MEMORANDUM

Re: **Applicant Response to DRC Comments**
501 Greene St. – 423 Front St. Transient License Transfer

423 FRONT STREET
 KEY WEST, FL
PERMIT SUBMISSION

1 PROPOSED 2ND FLOOR PLAN
A2.2 1/4" = 1'-0"

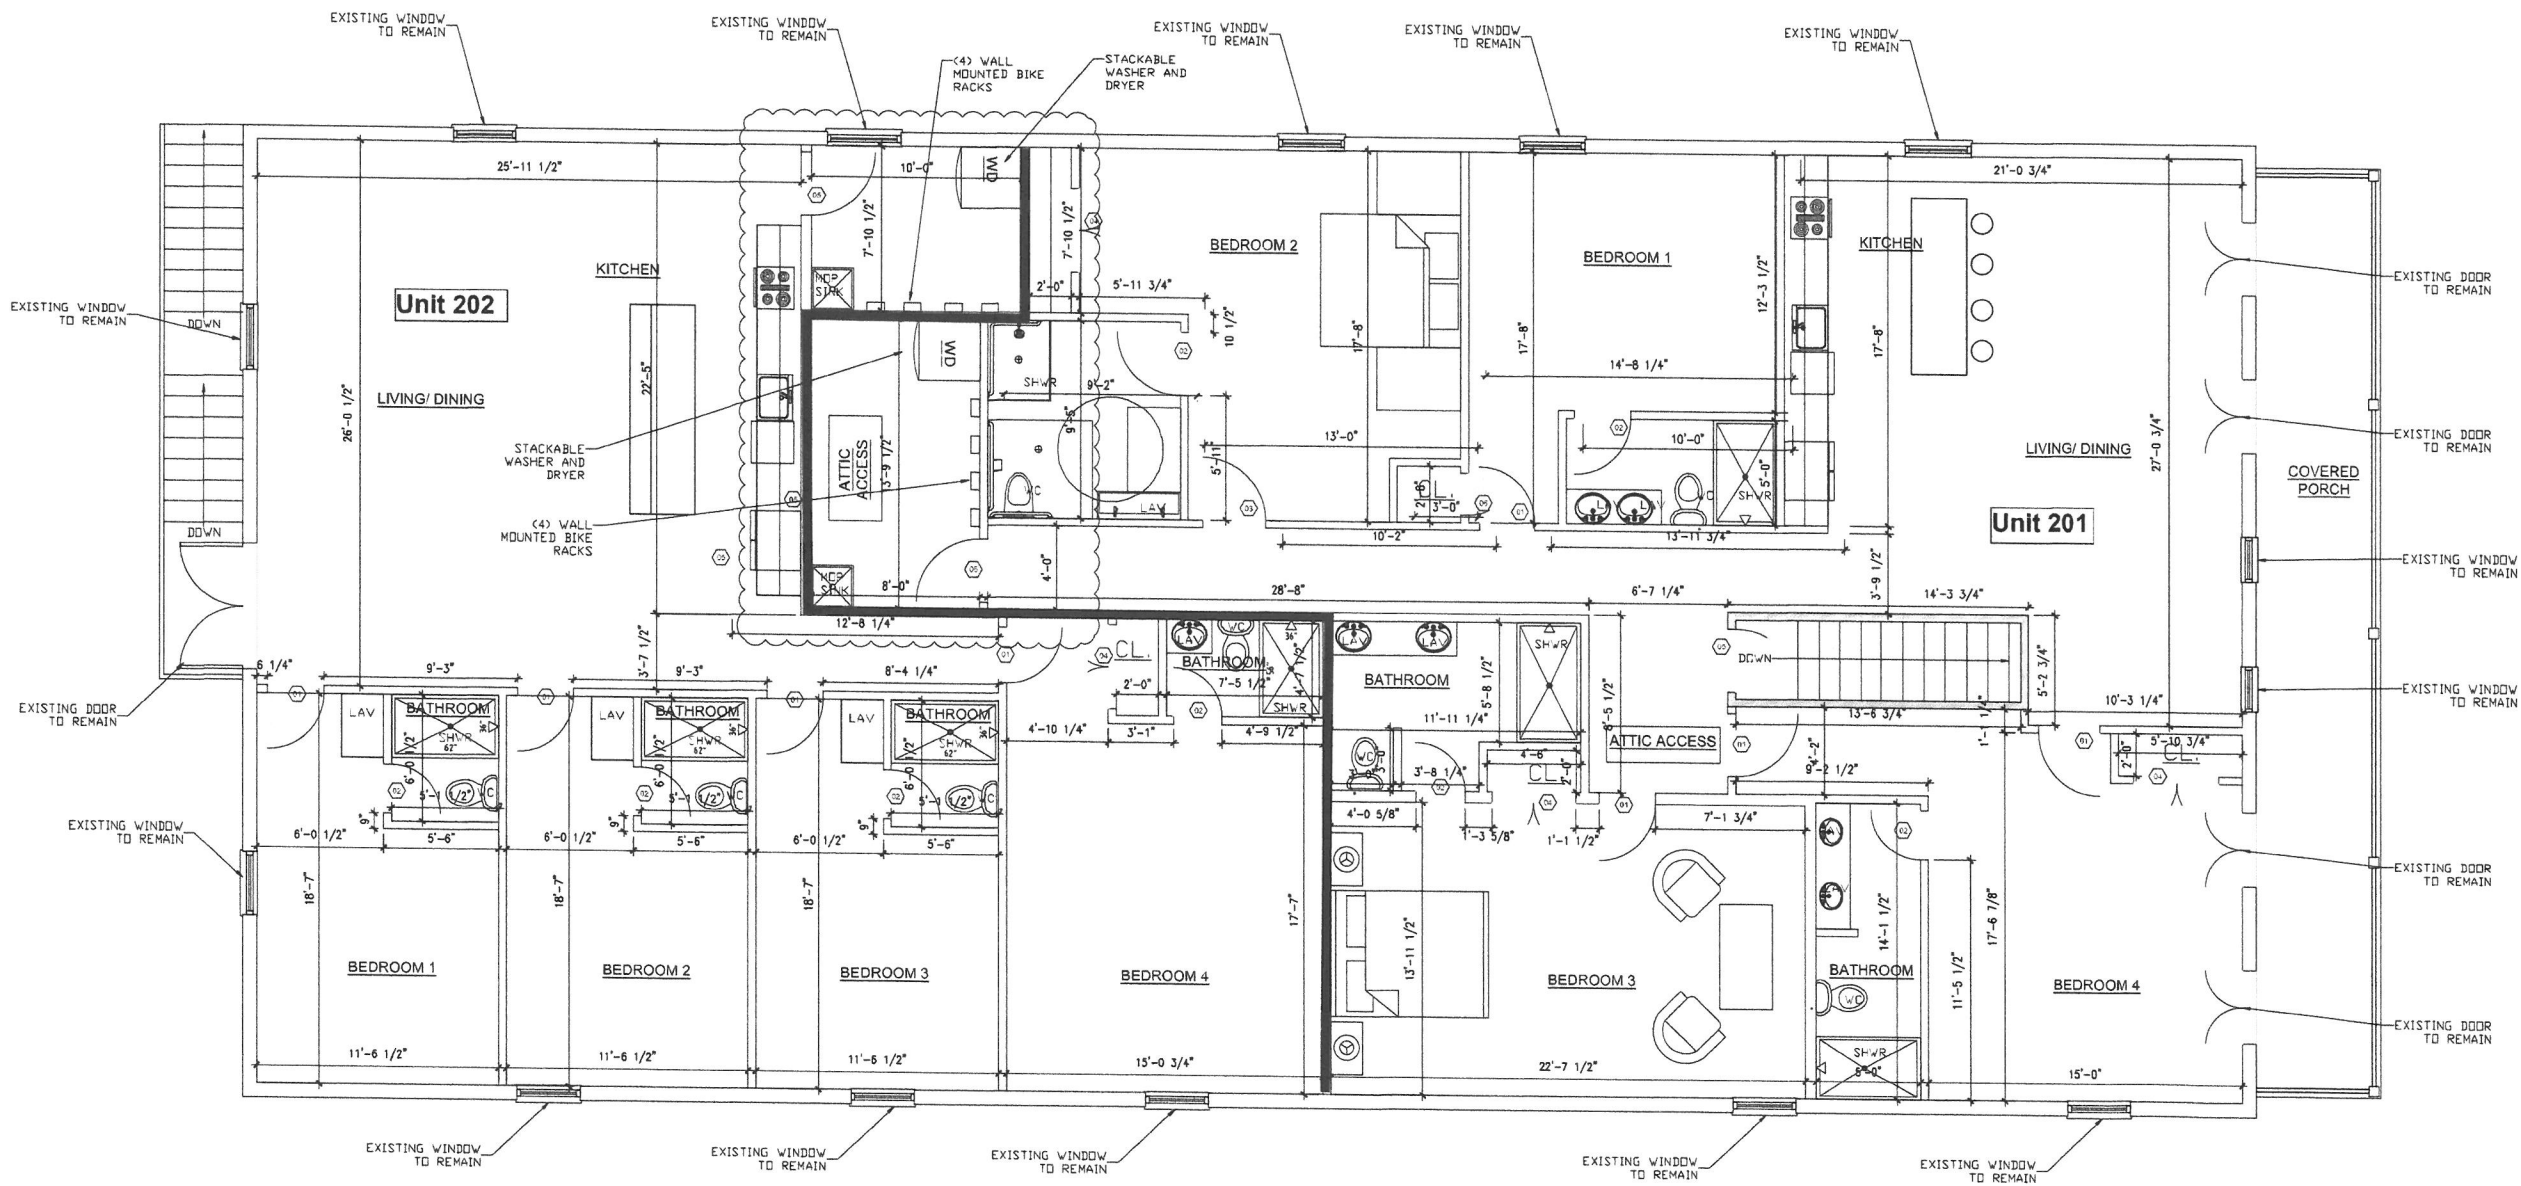
Receiver	GIS - If using alleyway for mechanical equipment, needs easement agreement with city	No exterior changes are proposed. Easements will be sought if required.
	GIS - Clarify unit nos. and locations of units	Please see attached floor plans
	GIS – C.O. the new units	Underway
Receiver	Fire - Close open permits and obtain C.O.'s for the new units	Underway
Receiver	Fire - Schedule and perform life safety site visit	Underway
